SSEC  
Technical Memo  
Project 1210

LINE START ERRORS IN THE SMS  
LINE-STRETCHER TIMING SYSTEM

29 August 1972

Figure 1

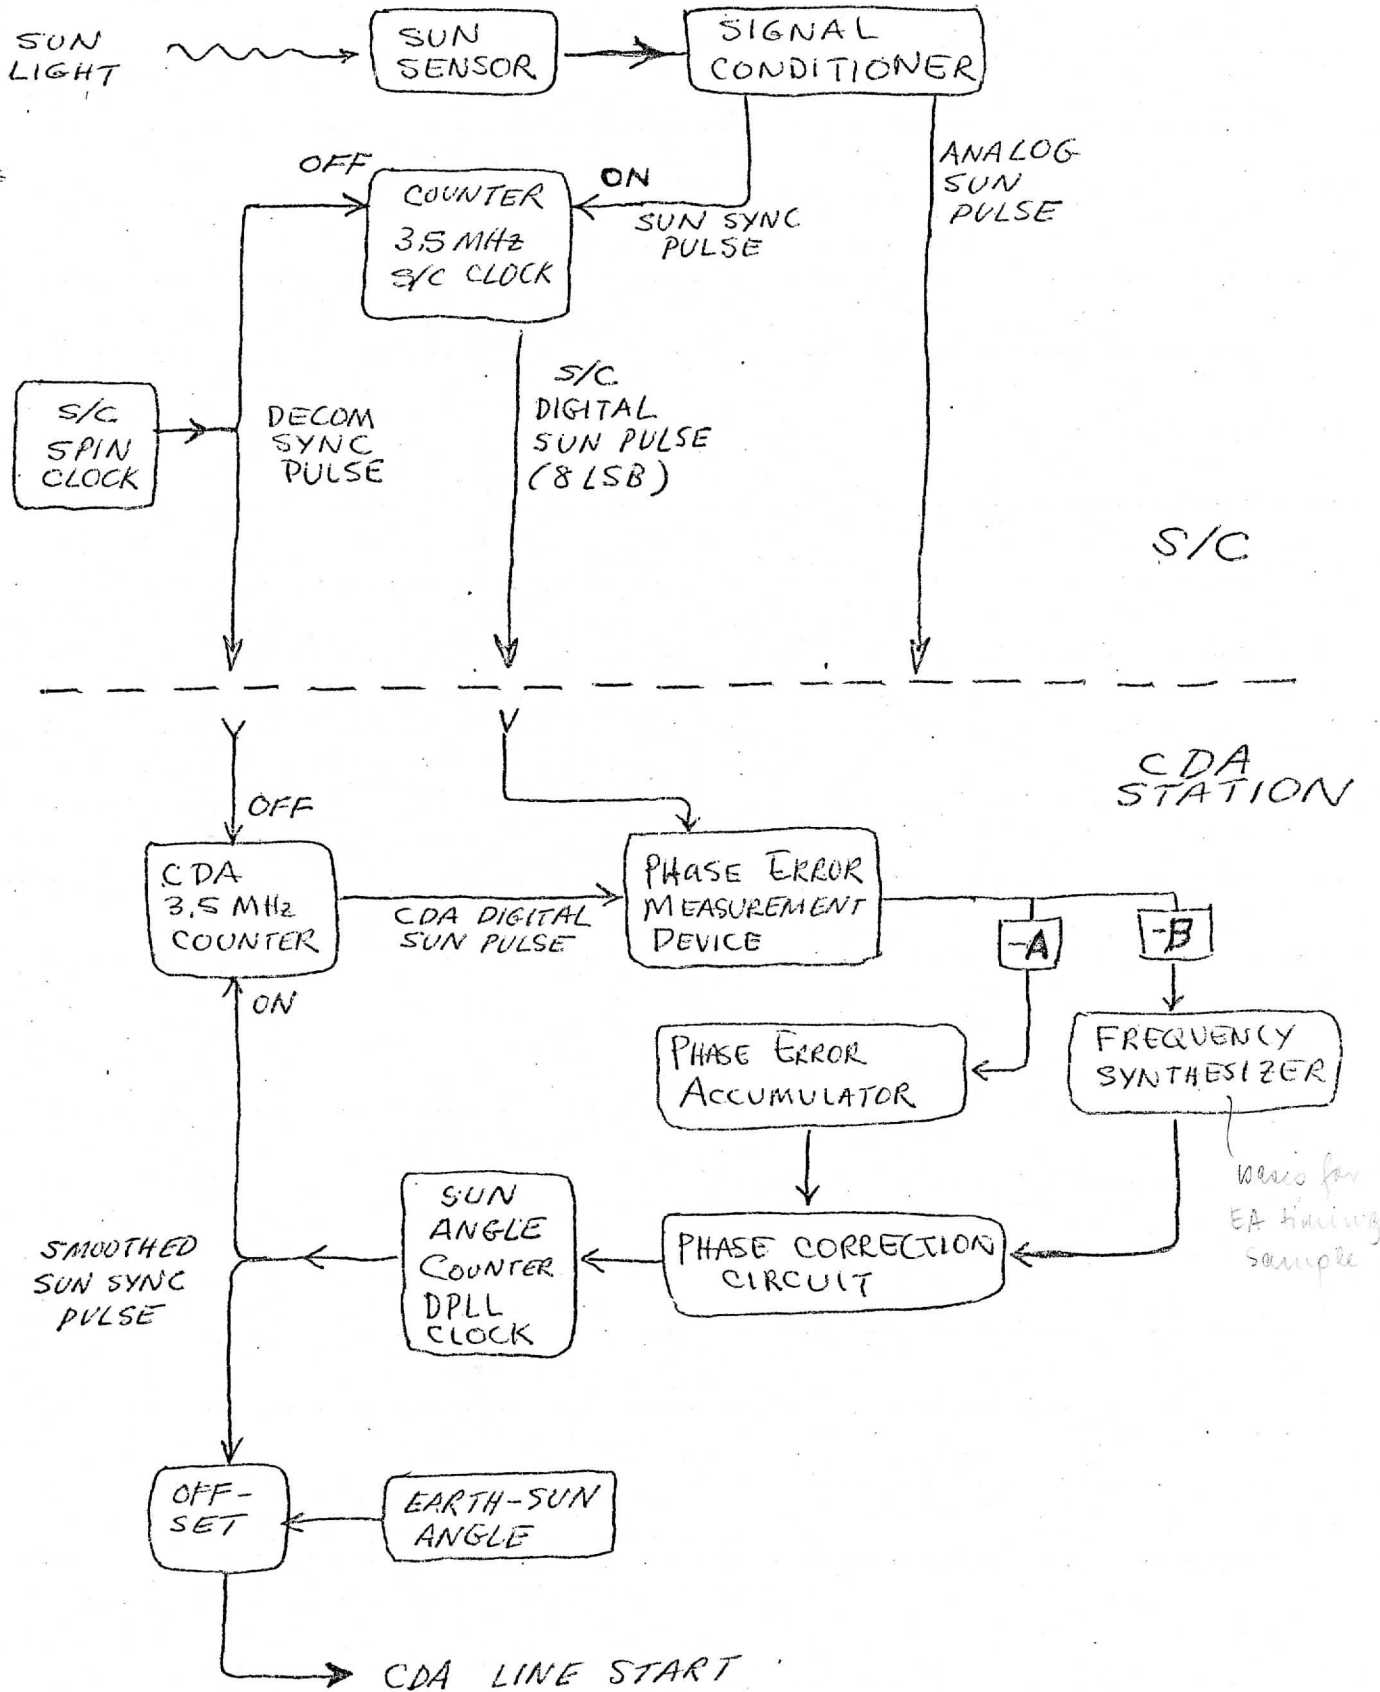
The SMS Line-Stretcher timing system is diagrammed in Figure 1. All timing information is derived from the output of the sun sensor on board the S/C, which produces one trapezoidal pulse per SMS rotation. The signal conditioner detects the time location of the leading edge of this pulse and creates two new pulses to specify it: an analog sun pulse (transmitted to the ground and used for coarse tuning of the CDA Phase Lock Loop); and a sun synch pulse which is used to turn on a S/C 3.5 MHz counter. At a later time determined by the S/C spin clock a DECOM SYNC pulse turns off the S/C counter and is simultaneously transmitted to the CDA station. The contents of the S/C 3.5 MHz counter are transmitted to the ground as the S/C DIGITAL SUN PULSE, which contains the 8 LSB (Least Significant Bits) of the number of 3.5 MHz clock pulses during the time interval between the SUN SYNC PULSE and DECOM SYNC PULSE.

In similar fashion the time interval between the smoothed SUN SYNC PULSE output of the CDA DPLL (Digital Phase Lock Loop) and receipt of the DECOM SYNC PULSE is measured by a CDA 3.5 MHz counter. The difference between this CDA DIGITAL SUN PULSE and the S/C DIGITAL SUN PULSE is the error signal used to provide phase and frequency corrections to the DPLL. The parameters A and B are adjustable and control the loop bandwidth.

The information which must be communicated to the CDA station DPLL is the time difference between the S/C SUN SYNC pulse and the DPLL output. The actual difference is between two digital 3.5 MHz counters, one on the S/C and one on the CDA station (see Figure 1), both turned on by the DECOM SYNC pulse. Errors produced in communicating this difference are:

Figure 2. Sun Sensor Signal Conditioner Block Diagram

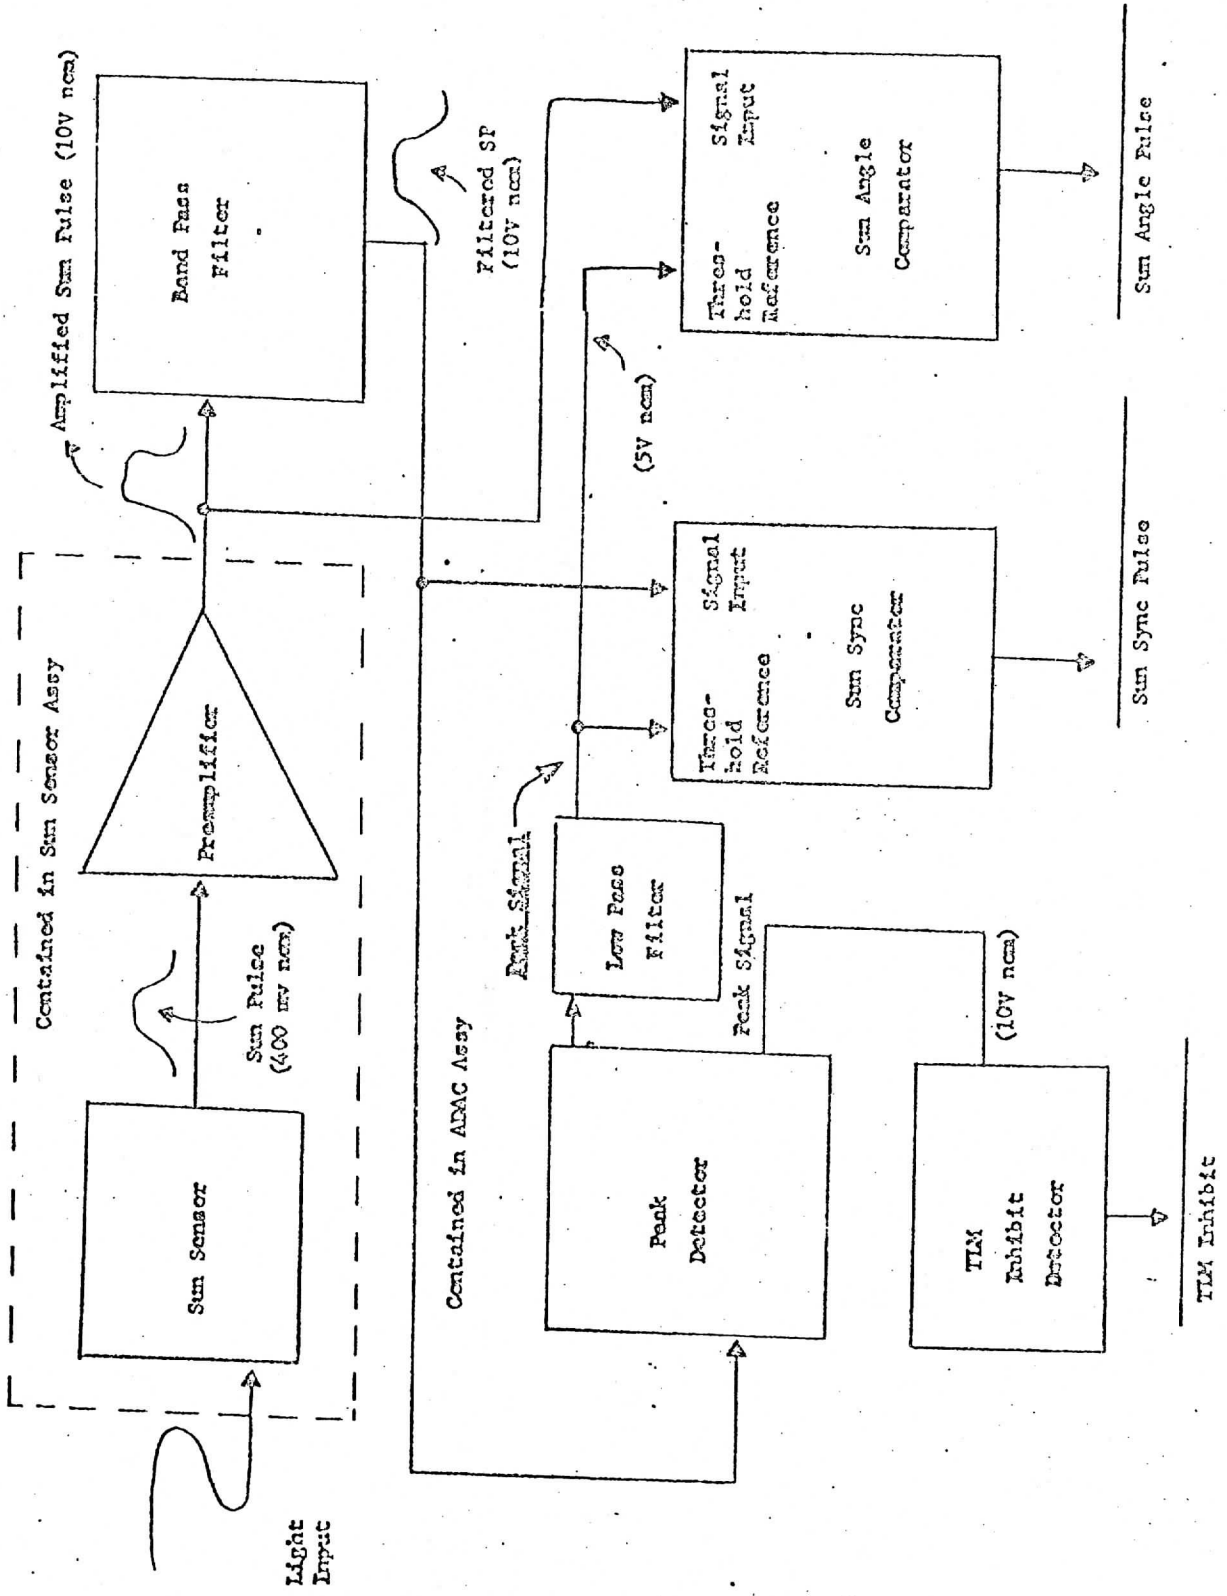
A functional diagram of this system is presented in Figure 2. Operation of the system can be described best by quoting from Vol. I, Book 2, Phase C Design Report, Philco Ford, 30 June 1971 (p. 14-3):

The time location of the 50% point of the sun sensor signal is communicated by the SUN-SYNC PULSE output of the threshold detector. The time jitter in the SUN SYNC PULSE is equal to the combined SUN SENSOR signal noise and threshold reference noise divided by the slope of the sun pulse at the 50% point (all quantities measured at the threshold detector input). Using a worst case

slope of 2.4 mV/ $\mu$ sec and a requirement of 1/3  $\mu$ sec RMS time jitter Philco-Ford established a total noise budget of 678  $\mu$ V at the threshold detector. Combining the effects of sun sensor noise, preamp noise, bandpass filter noise, peak detector and low-pass filter noise, threshold detector noise, spacecraft harness noise, and gain variation (some quantities measured and some estimated), they concluded that the system noise would not exceed the specified budget. Philco Ford also conducted laboratory tests on the sun sensor signal conditioner and preamplifier circuits using a simulated sun sensor input pulse. Results showed a probable RMS time jitter of 0.330  $\mu$ sec and a worst case RMS jitter of 0.38  $\mu$ sec (Philco-Ford, Phase C Design Report, Book 2, Vol. 1, 30 June 1971, p. 14-17). The latest SMS Error Budget up-date (Philco Ford, SMS-PCC-3577, 14 February 1972), indicates an RMS time jitter of 0.343  $\mu$ sec and a DC offset error of 0.0292  $\mu$ sec.
